Item 8.**Section 4.55 Application: 890-898 Bourke Street, Zetland**

File No.: D/2015/98/B

Summary

Figure 3 - Amended ground floor envelope with location of original courtyard shown in red

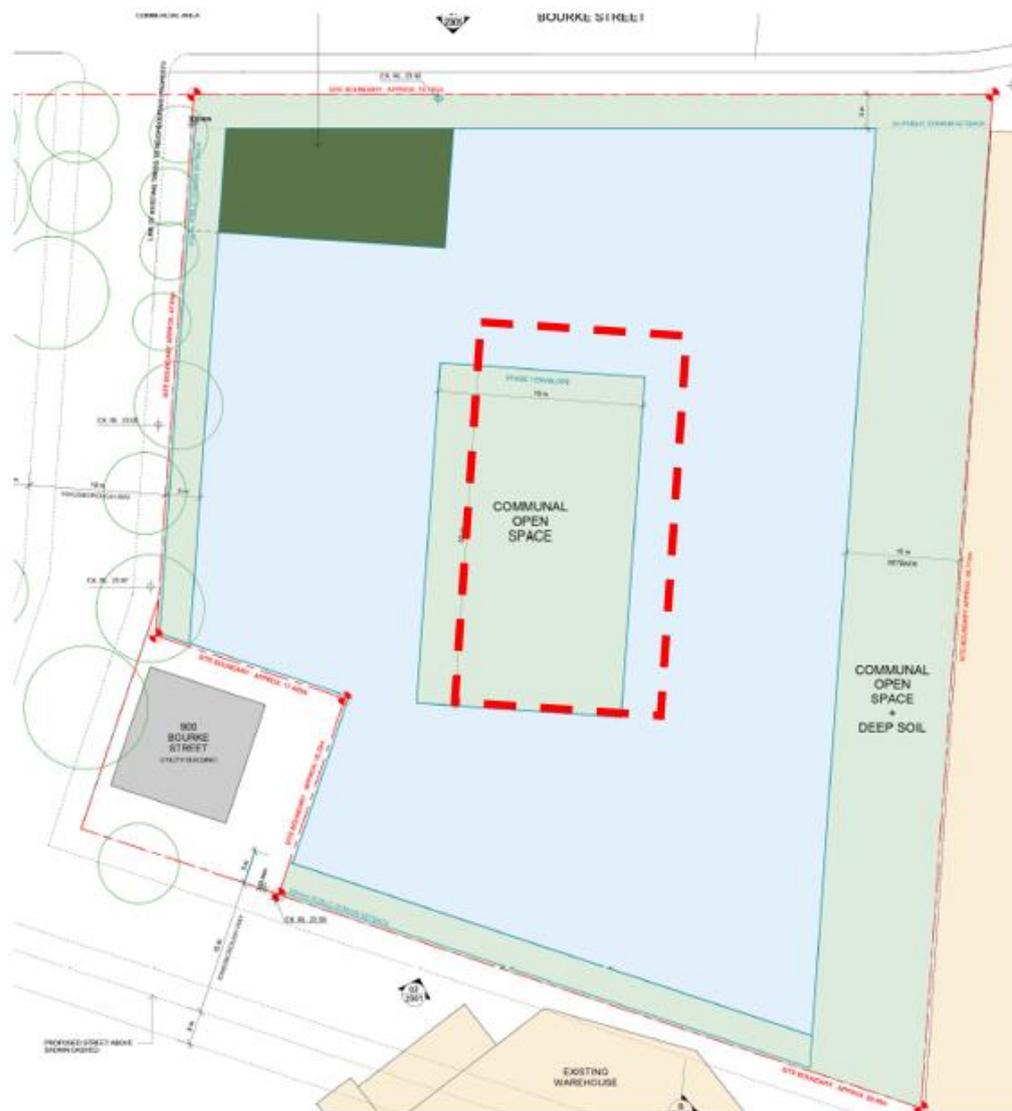
14. The Section 4.55(2) application seeks to amend the existing concept envelope to -
 - Relocate the central internal courtyard 4m to the west and reduce the length of the courtyard by 5m. The proposed courtyard will measure 18m wide and 30m in length.
 - Replace a deep soil planter measuring 25sqm with a deep soil planter to a depth of 1.2m for the entire courtyard area.
 - Extend the basement envelope to accommodate two full basement levels.
 - Include an additional lift pit in the basement level 2.
 - Include the 300mm setback for the land to be dedicated to the City for footpath widening on Kingsborough Way.
15. Conditions 2, 4 and 11 of the consent are to be modified to reflect the amended plans and the detailed development application as proposed.
16. There are no changes to the height of the envelope or the setbacks from the boundaries as originally approved.

Figure 5 - Amended section showing increased basement at Level 2

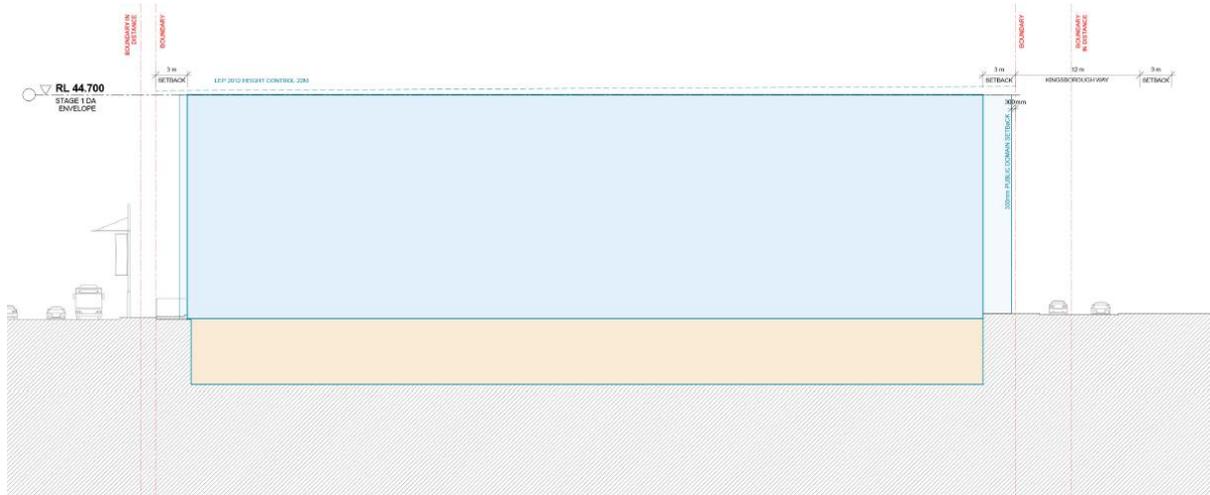
39. The increase to the extent of the basement ensures there is adequate space on-site to accommodate the required car, motorcycle and bicycle parking and service areas.

Figure 6 - Proposed building footprint in grey as shown in relation to the approved building envelope (hatched)

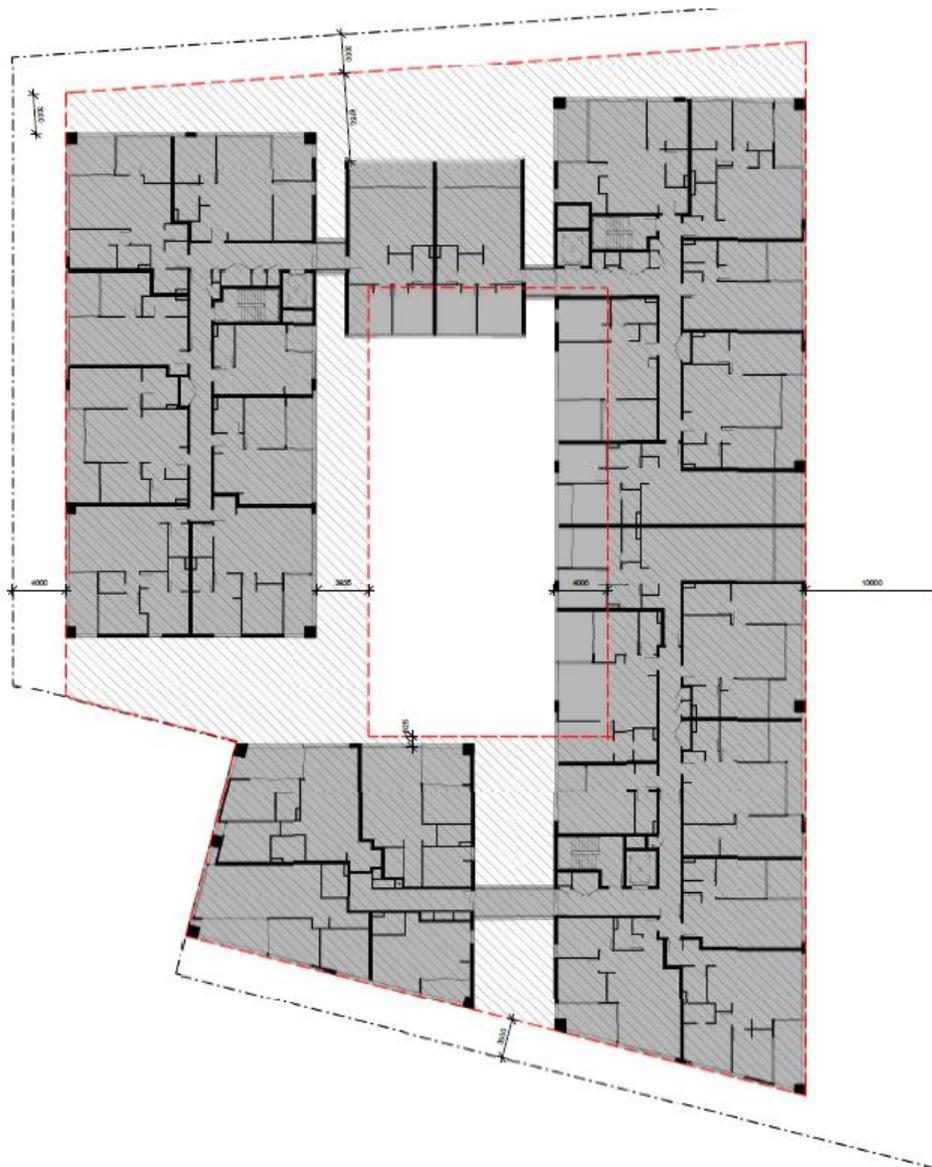
35. Although 5m has been added to the depth northern part of the building envelope. The detailed DA proposes a building with a maximum depth of 16m which is less than the 18m maximum building depth recommended by ADG. ? wording
36. There is no change to the overall building height and setbacks from the property boundaries. The amendments to the central courtyard and basement will not be visible from the surrounding context.
37. There is no additional overshadowing created by the amended envelope. The amended shadows will be contained within the shadows cast by the approved building envelope.
38. The detailed DA has demonstrated the amended courtyard allows the development to comply with the ADG requirements for solar access and cross ventilation.
